Date: 04/12/05
Scale: 1/4"=1'-0"
Drawn By: MTA
Project: Q1041205
Sheet Number:

FRONT ELEVATION

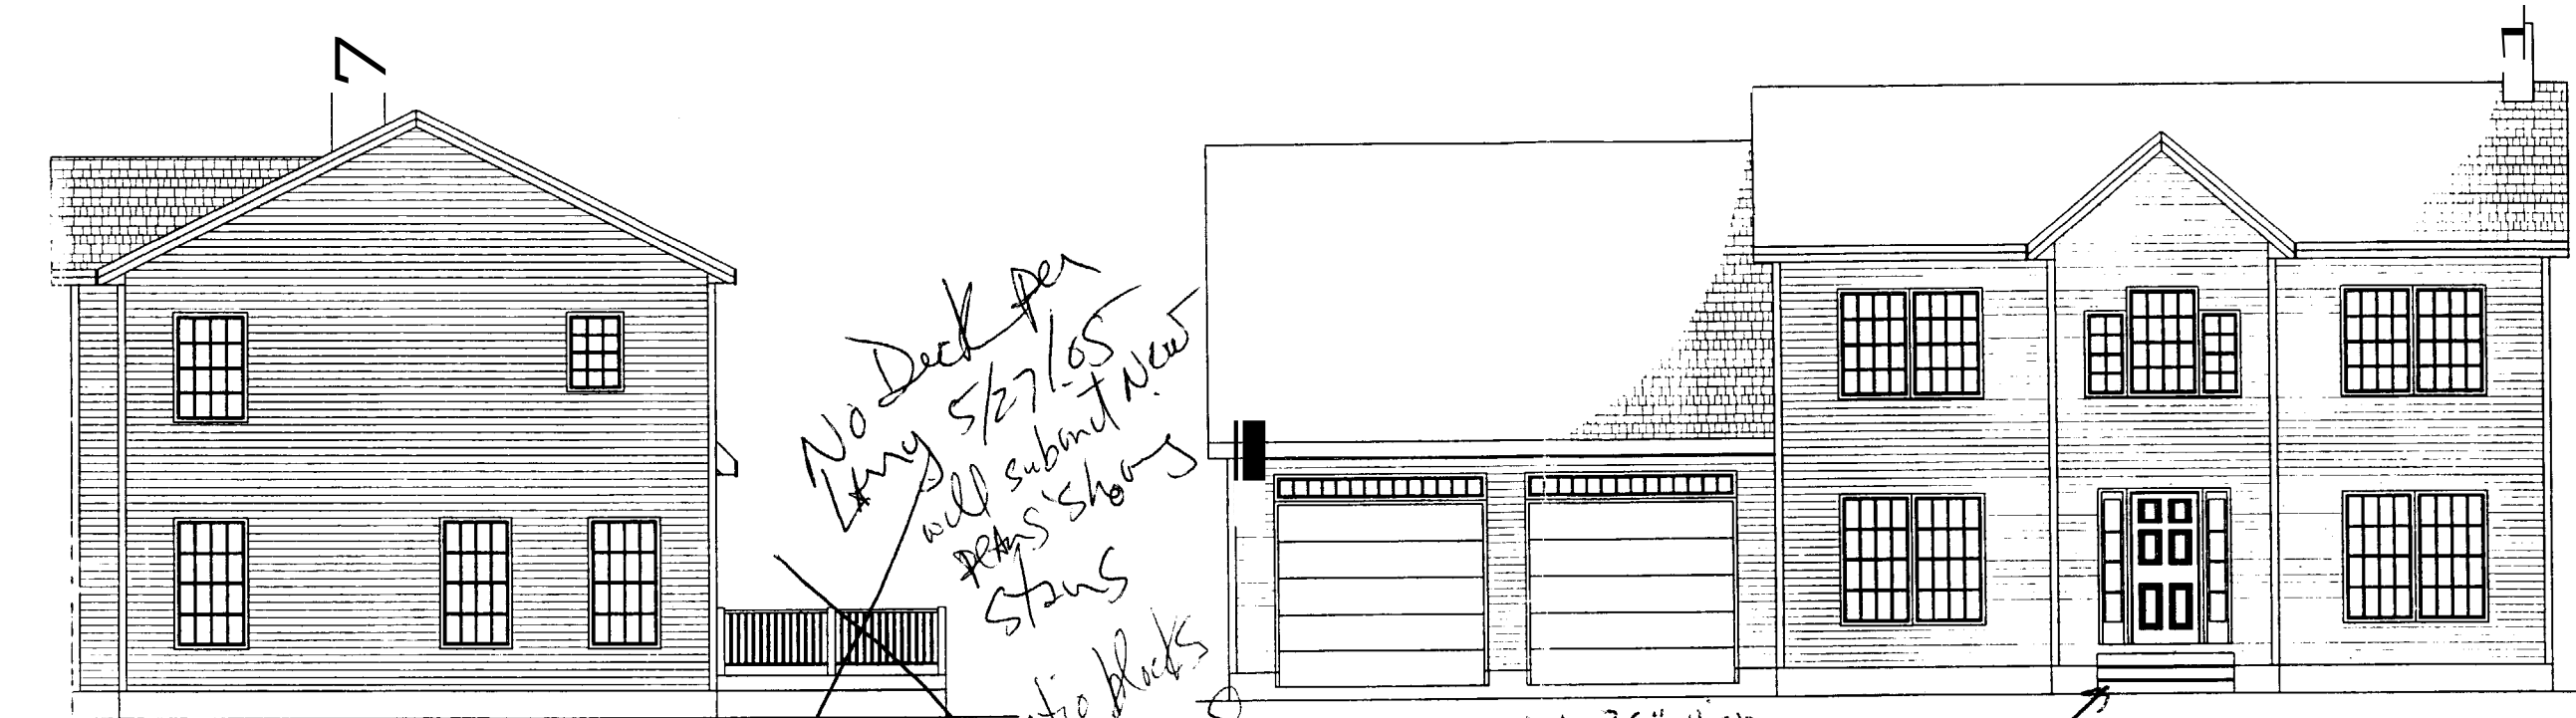
No Deck per
Larry 5/27/05
will submit New
Plans Shows
Stairs
patio blocks
2 Stairs

Handrail 30" High
Ballusters
Spaced
4' O.C.

Precast
Steps
3 R-7"
2 T-11"

LEFT ELEVATION

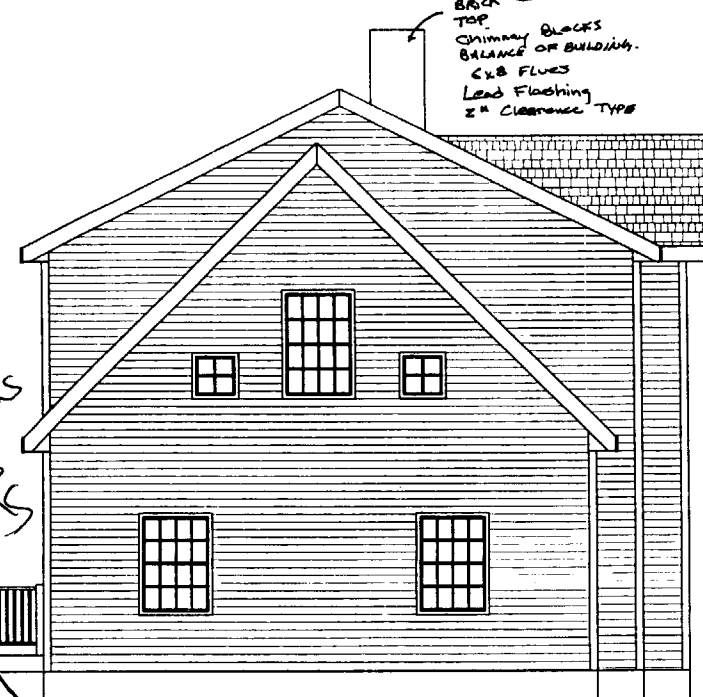
No Deck per
Larry 5/27/05
he will
submit plans
Shows
Stairs

Patio
2 Rises to House
② R@ 7"
① T@ 11"
Patio to Ground
① R@ 7"

No Deck
Stairs only in patio Blocks

① Granite Steps
② R@ 7"
① T@ 11"

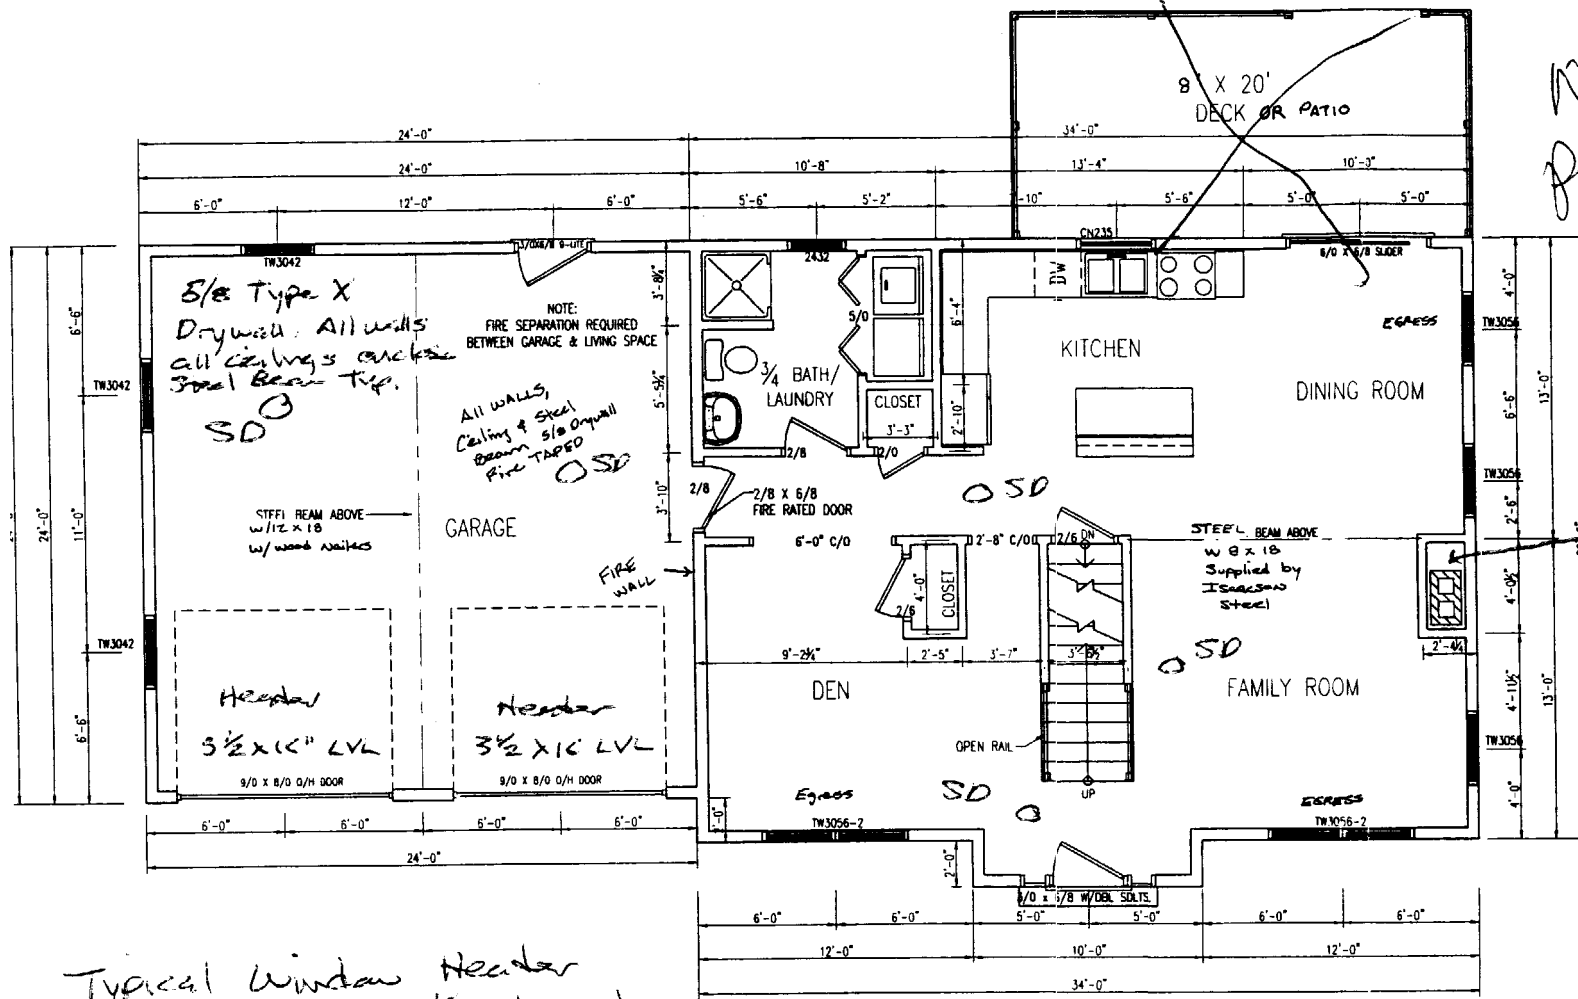
No Deck
per Larry
5/27/05

* Smoke Detector
located in Attic
typ. And in Basement

2" clearance
around chimney
typ. All Floors
See Note 1 of 3

Safety Glass

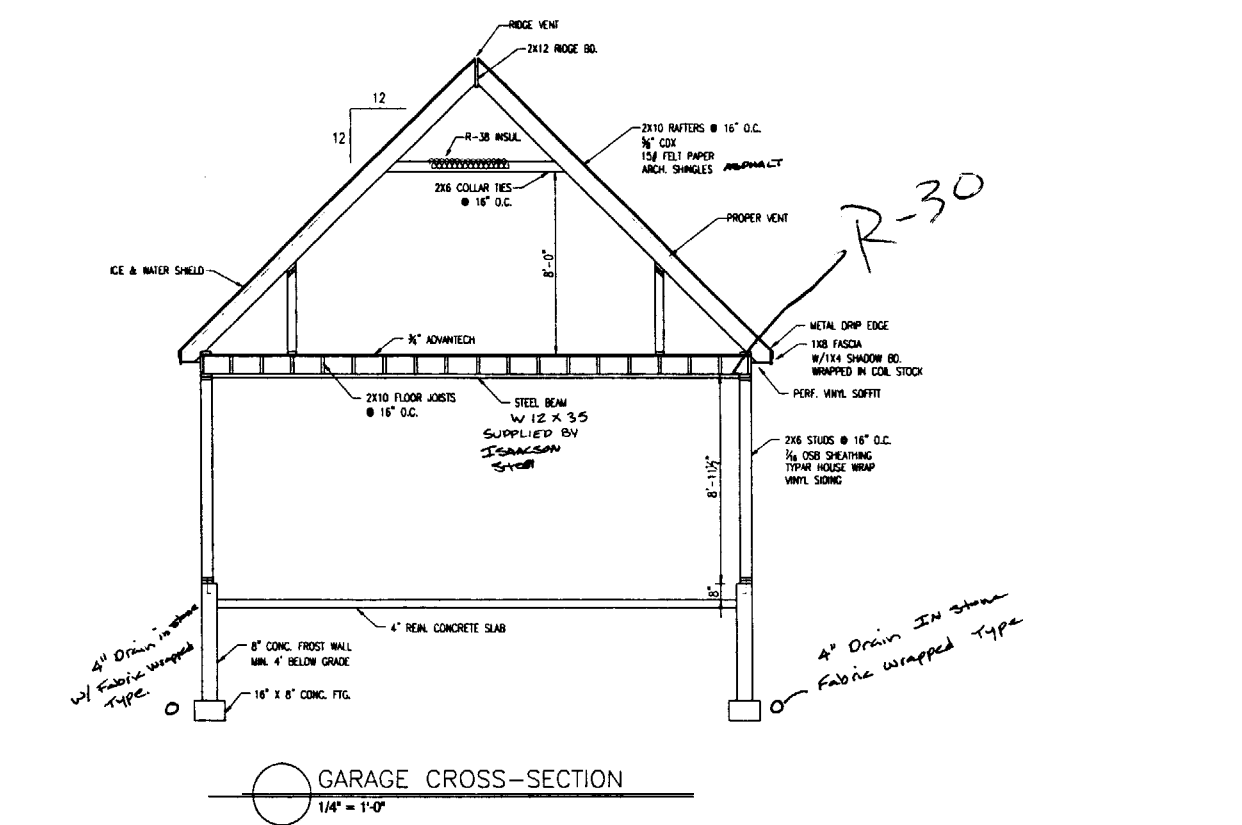
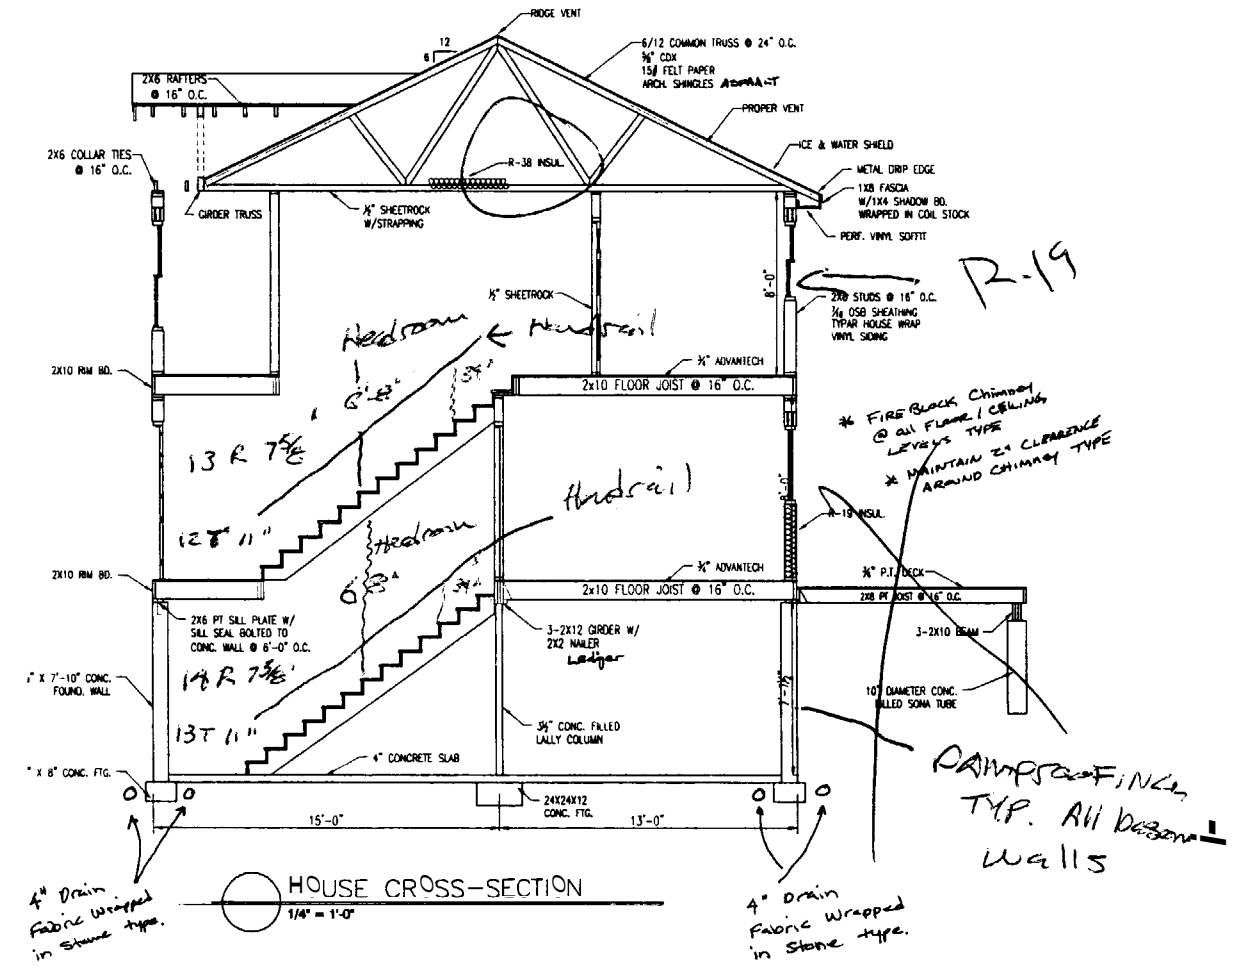
No Deck per Larry 5/27/05
